**DEVIATION REVIEW
AND DECISION FORM**

Deviation No. 2

Subdivision or Project Name: Rollin' Ridge Estates

Cherry Crossing Drive Intersection Spacing

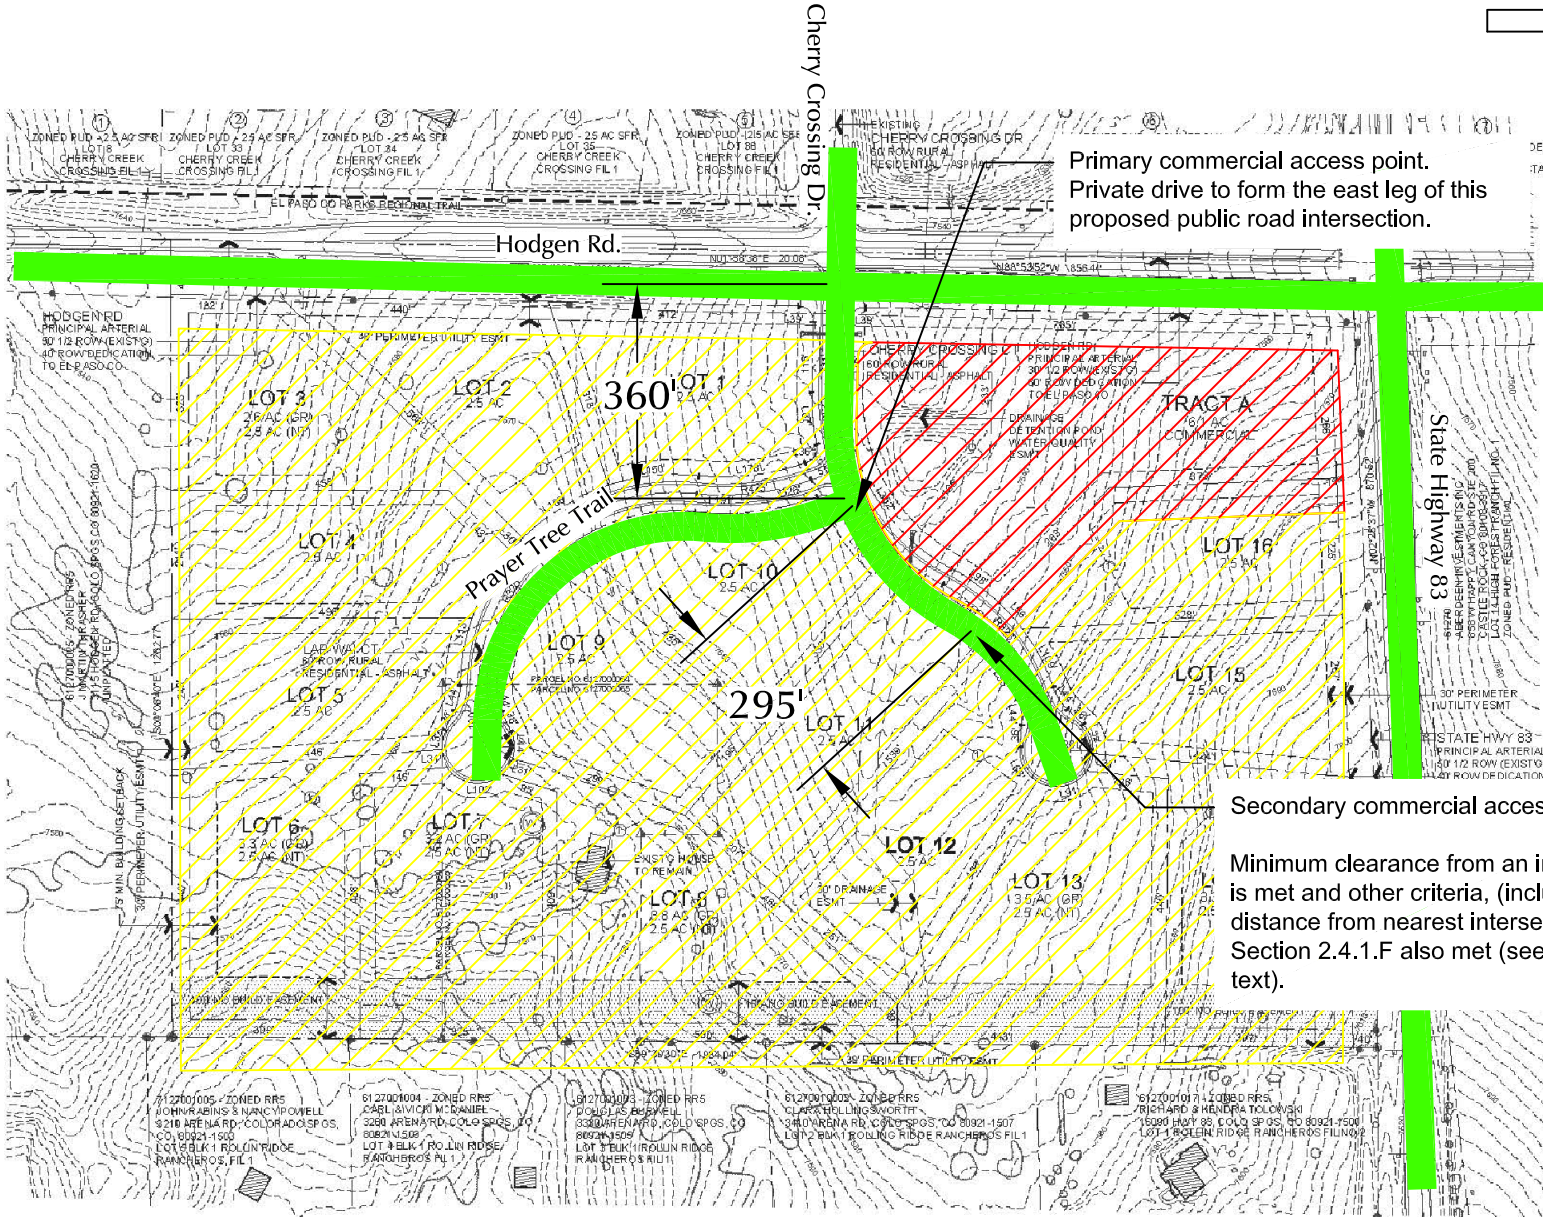
Proposed Nature and Extent of Deviation: The ECM-prescribed intersection spacing along a Rural Minor Arterial is one-quarter mile. This deviation request is to allow a spacing of 360 feet instead of the ECM-prescribed one-quarter mile spacing. This spacing is for Cherry Crossing Drive between Hodgen Road and the first public road (Prayer Tree Trail) intersection to the south of Hodgen (Note: the east leg of this intersection will be the proposed north commercial access driveway-a private leg of a public street intersection). Please refer to the attached exhibit.

Reason for the Requested Deviation: The deviation for the spacing less than one-quarter mile is needed as the entire depth of the site (south from Hodgen Road) is not one-quarter mile. The 360-foot intersection spacing is requested as this would allow the first public road (Prayer Tree Trail) intersection south of Hodgen Road to be closer and a more reasonable distance south from Hodgen Road given the size/scale of the proposed development.

Comparison of Proposed Deviation to ECM Standard: The proposed centerline intersection spacing along Cherry Crossing Drive between Hodgen Road and this first public street intersection is 360 feet. This spacing is 960 feet short of the ECM standard intersection spacing of one-quarter mile.

The 2040 queuing analysis contained in the TIS indicates that the proposed intersection spacing will be sufficient to accommodate vehicle turning movements, projected vehicle queues, turn lanes of sufficient length and associated tapers (please refer to separate deviation for turn lane lengths), and sufficient intersection and stopping sight distance. Please refer to the attached exhibit showing the intersection spacing for this section of Cherry Crossing Drive.

_____ Date _____
This request has been determined to have met the criteria for approval. A deviation from Section 2.3.2 of ECM is hereby granted based on the justification provided. Comments:
